# HARDWARE PATCH for Zemmix Neo, SX-1, SM-X and related machines ( update 2020.04.06 )

## 2020.08.19 Hardware Patch for OCM machines “aka BUSDIR\_n patch”

## 2020.10.16 Hardware patch for Zemmix Neo BR machines (aka +5V line stability fix)

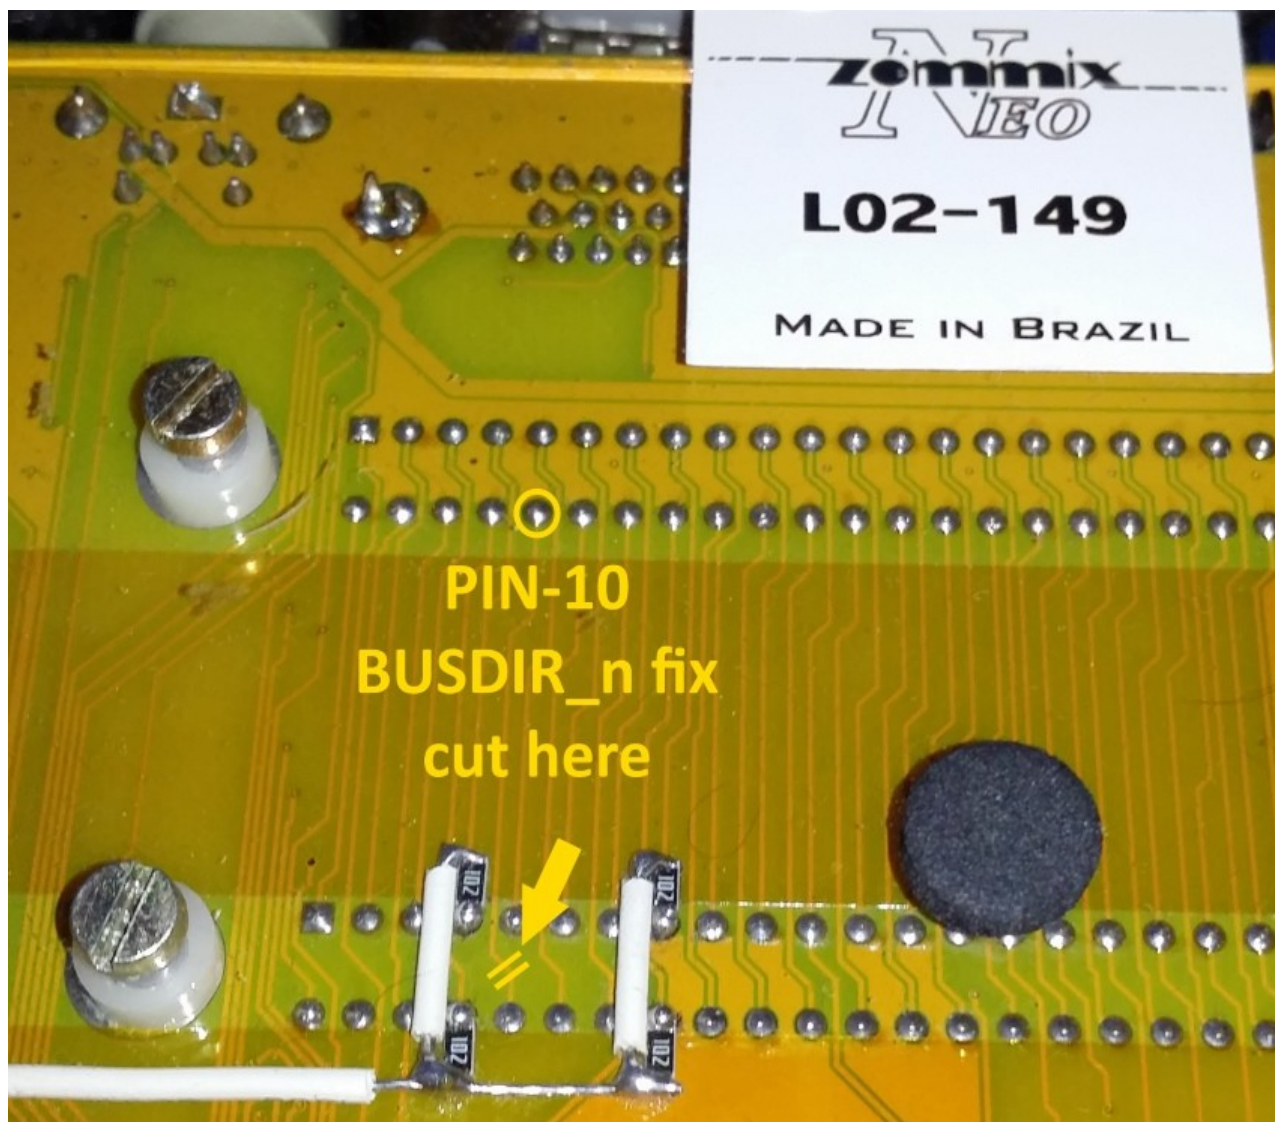
- In OCM machines we have a short circuit between pin-10 (BUSDIR\_n) of the two external slots that continues towards the FPGA. This type of connection confuses some cartridges.
- While the Panasonic FS-A1ST and Canon V-20 service manuals confirmed that the BUSDIR signal is not used.

- Pin-10 (BUSDIR\_n) of the external slots must be isolated.

- Method 1 - Cut the track that connects pin-10 of Slot-1 and Slot-2 leaving unchanged the connection to the FPGA already internally isolated by the firmware.
- Method 2 - Desolder pin-10 of slot-2 from the PCB and insulate it with the sheath of an electric wire and a drop of hot glue.
- Method 3 - Place non conducting tape over pin 10 of those cartridges that are not working properly, such as MoonSound and Darky.

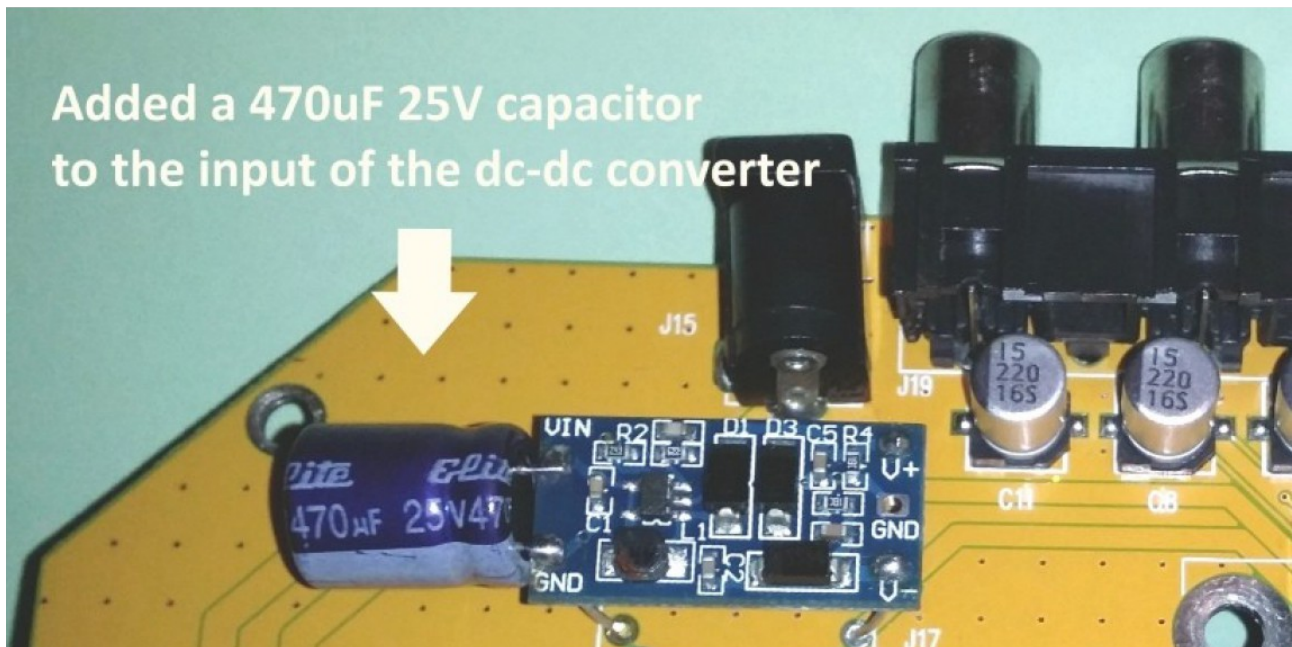
Based on the wiring diagram of the original 1chipMSX machine, I have implemented this new hardware patch for Zemmix Neo Brazilian which allows to stabilize the +5V input line. This patch can for example remove some annoying video interference on the output of GFX9000 and other similar cartridges. Please be informed that the problem is currently only present on Zemmix Neo Brazilian and not with Zemmix Neo Korean, but this fix can still be used if your hardware is unstable.
